# NEW MEXICO ENERGY, MINERALS and NATURAL RESOURCES DEPARTMENT

**Re: Injection Pressure Increase -175  
Stella Needs A Com Well No. 1E SWD  
San Juan County, New Mexico**

Re: Step Rate Test – Stella Needs A Com No. 1E SWD

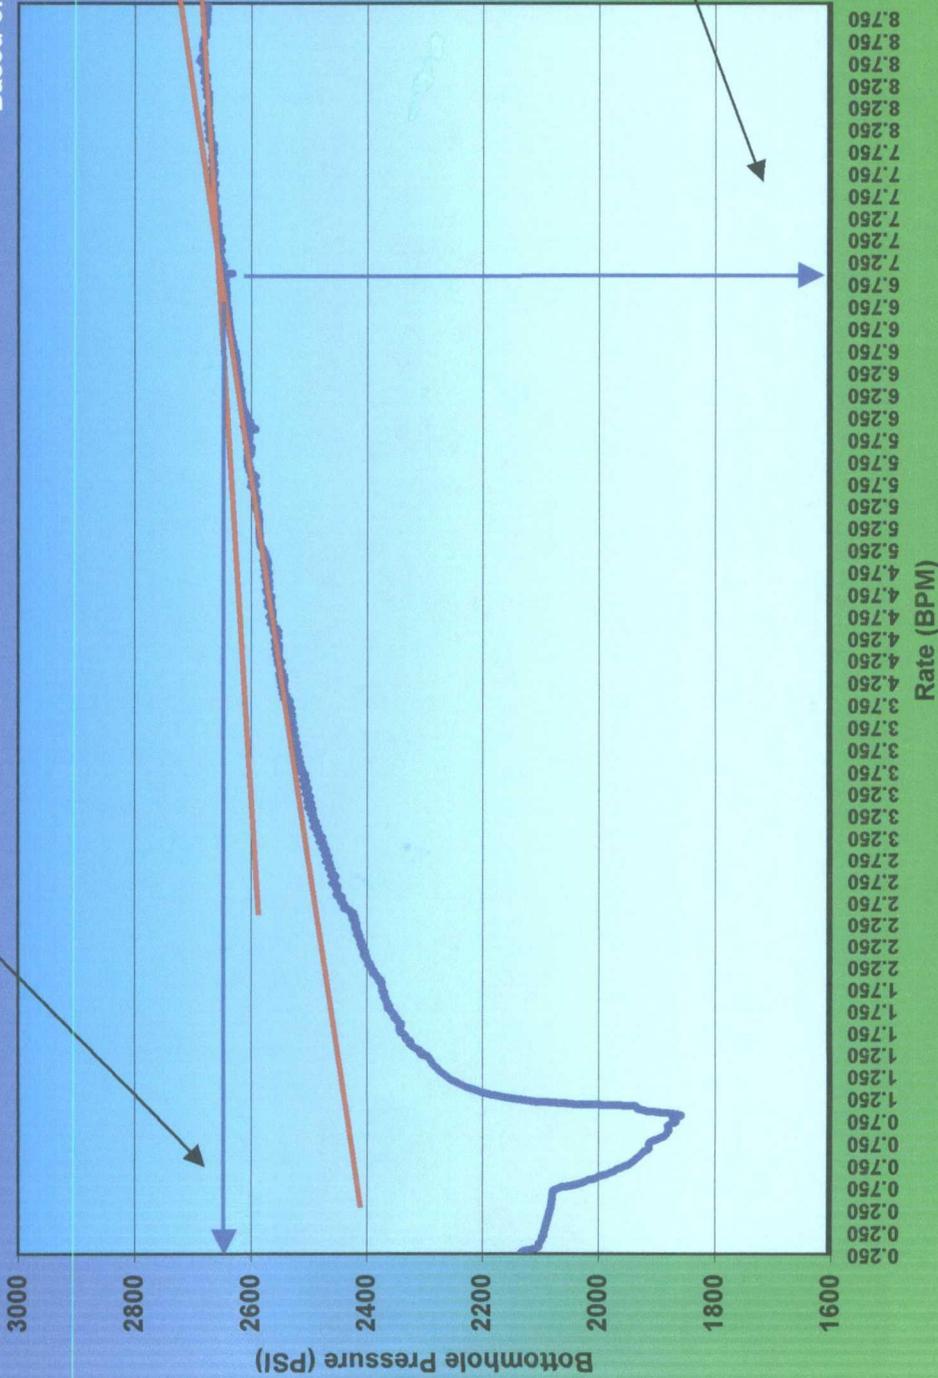
BH FRAC Pressure @ GUAGE = 2662

@ Top Perf = 2670

( - GRADIENT = 1606 ← .4417 x 3635 )  
+ FRICTION = 550

SURFACE = 1614  
( - 50 PSI Safety ) = 1564 PSIG

Stella Nees A Com No. 1E SWD - Step Rate Test Data 4/2/2002

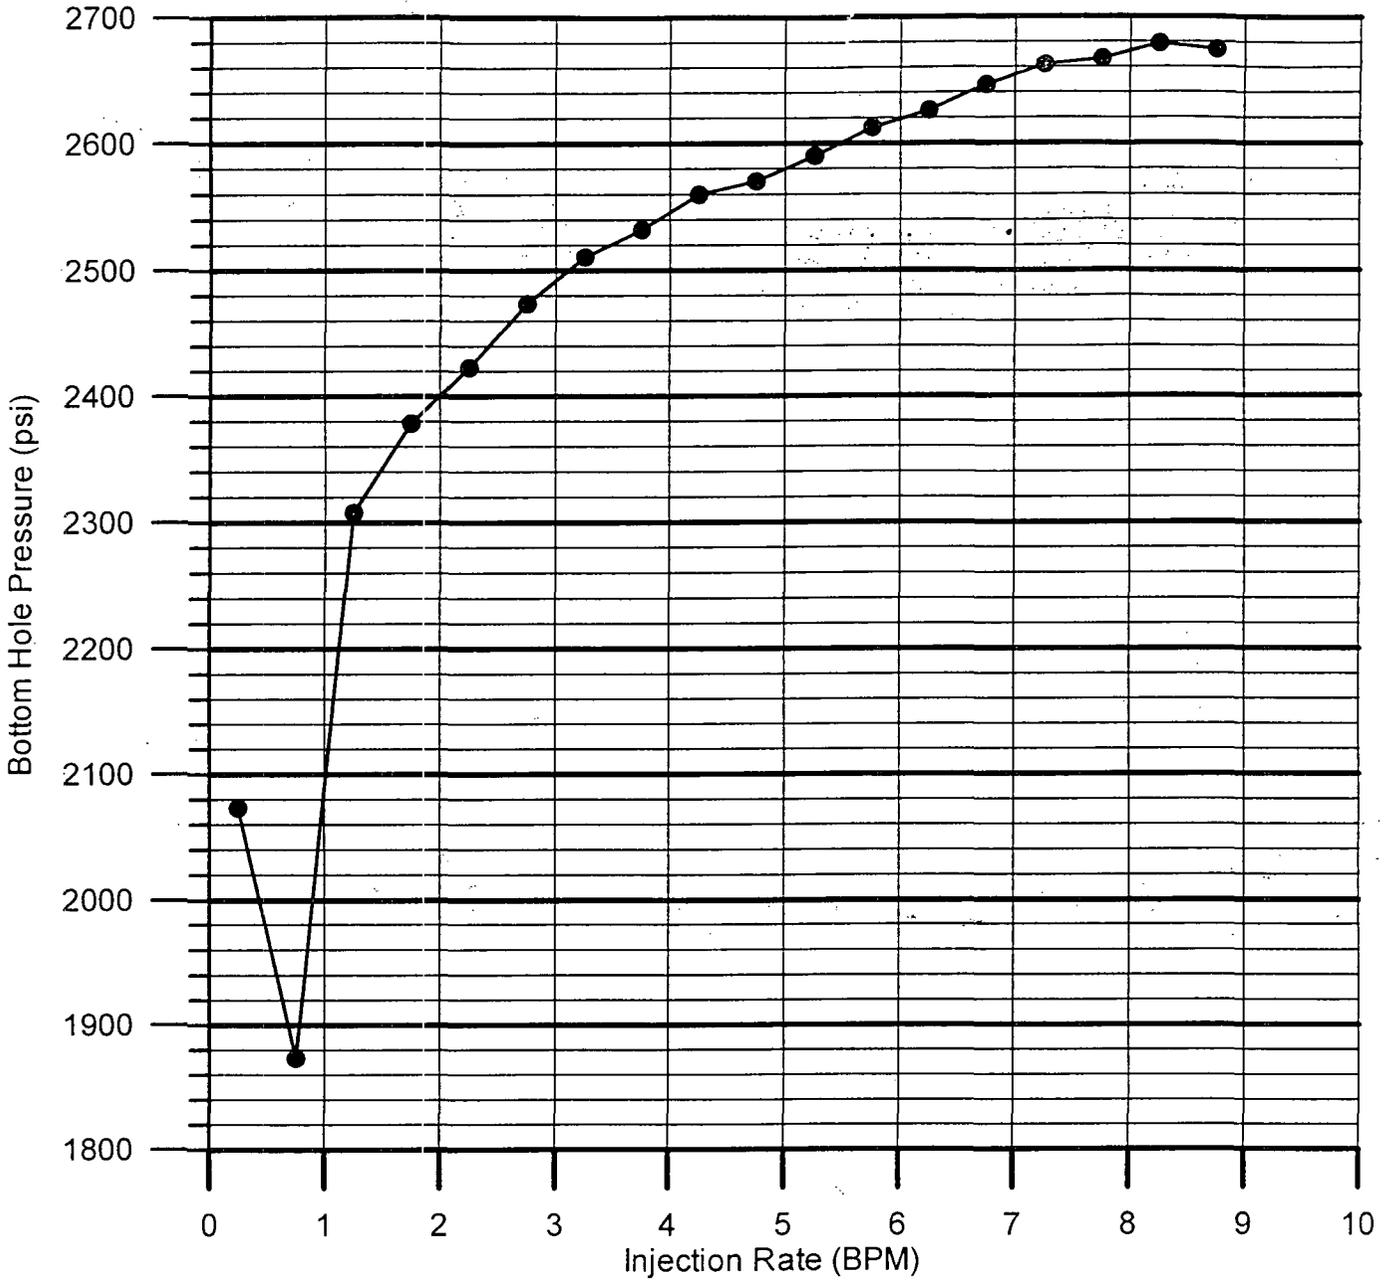
BHP @ Fracture = 2630 PSI  
Based on Graph Below

Top part  
 2612 + 6 = 2618

← 50 PSI - HYDRO + FRICT  
 1606  
 1400  
 150

1562 Surfer
